Randwick Local Planning Panel (Public) Meeting

Development Application Report No. D7/26

Subject: 25-27 Church Street, Randwick (DA/1205/2025)

Proposal:	Demolition of existing building/structures and construction of a part-8 and part-9 storey residential flat building comprising 8 apartments (2 x 2-bedroom and 6 x 3-bedroom) and basement parking for 10 parking spaces, associated ancillary and landscaping works.
Ward:	Central Ward
Applicant:	Mr D Pireh
Owner:	Zeebrr Pty Ltd
Cost of works:	\$2,989,939.00
Reason for referral:	The development contravenes the development standard for number of storeys by more than 10%; the development is subject to Chapter 4 'Design of residential apartment development' of the Housing SEPP 2021 as the proposed development is for the erection of a new building that is 3 or more storeys and contains at least 4 dwellings; and 14 unique submissions by way of objection were received.

Figure 7: Overlay of survey (green) and roof level (red) (source: Council Officer)

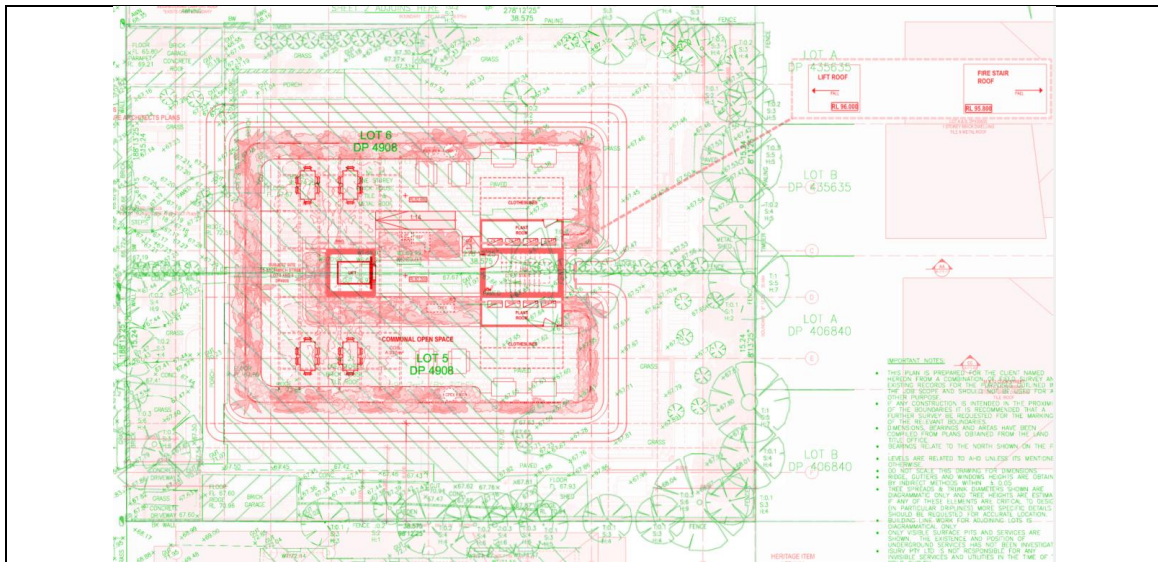
<p>Inaccurate calculation of building height</p> <ul style="list-style-type: none"> - Should be 29m rather than 28.6m - Lack of information in the survey to confirm if the 28.6m is complied with across the site - Lack of 3D height planes to confirm the height is compliant 	<p>It is agreed that the proposal was not accompanied by a 3D height plane to demonstrate compliance with building height.</p> <p>However, the assessing officer has compared the proposal with the survey to confirm the maximum building height proposed, which appears compliant (refer to Figure 7).</p>

Figure 9: Plan showing indicative building envelope and massing analysis (Source: Archispectrum)

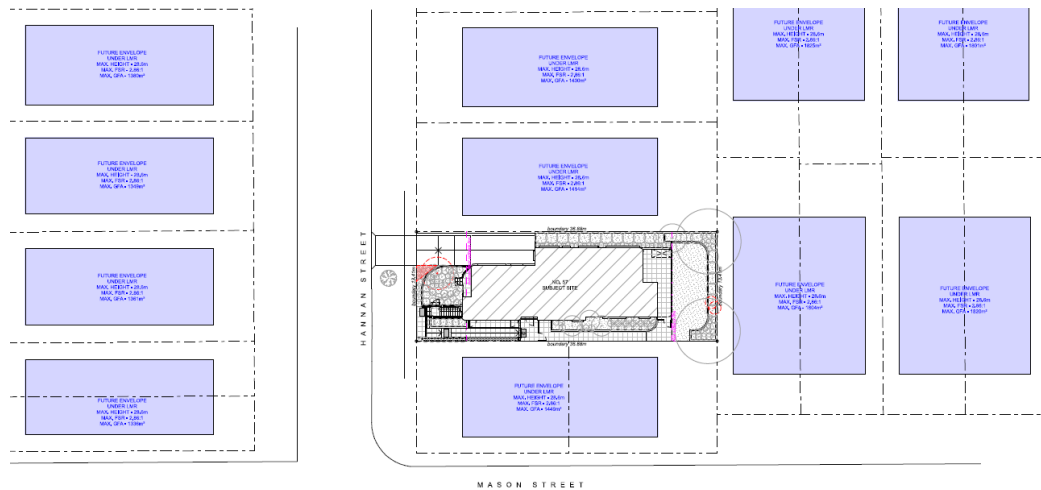
The submitted modelling of indicative envelopes fails to provide the required detail including building separation analysis, layouts, solar compliance, etc.

The submitted modelling also contemplates 9 storey development to the western side of Hannan Street, which is inaccurate as this side of the street is within the R2 Zone and therefore not subject to the non-discretionary development standards that allow for a 6 storey residential flat building pursuant to section 180 of the Housing SEPP. Council considers that the LMR should form the precedent that informs the desired future character (if appropriate in the context) and that the additional height and bulk associated with the infill affordable housing is not a supportable outcome in the context of the current site context and wider urban block.

Figure 10: Sun eye diagrams showing indicative building envelope and massing analysis (Source: Archispectrum)

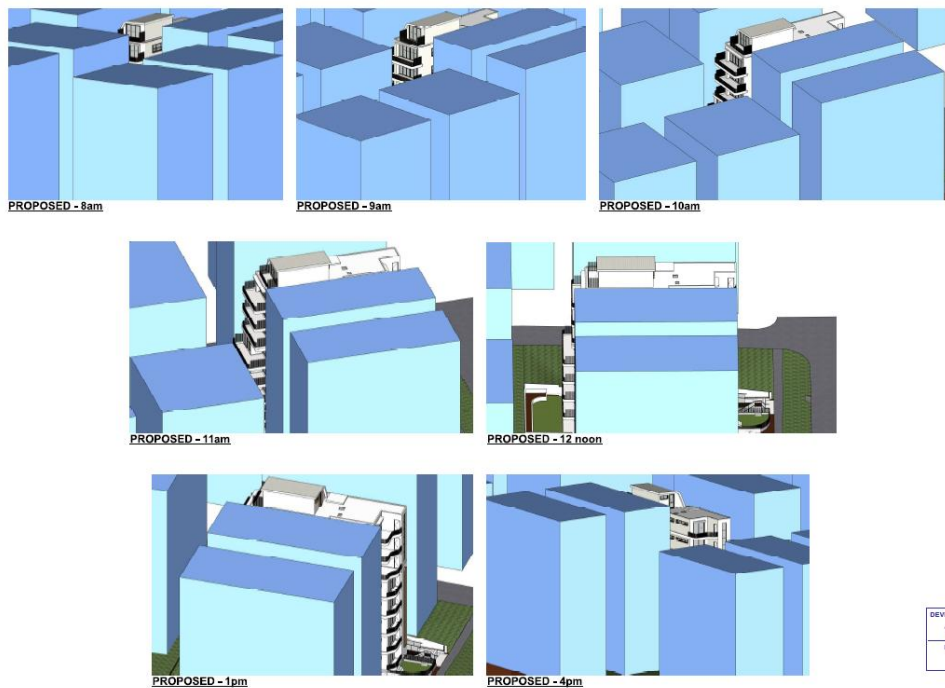
The applicant has failed to adequately consider and demonstrate what the desired future character of development of the precinct. Council is not satisfied that the proposed development is in keeping with the desired future character of development in the area and therefore the scale of the proposed development is not supported.
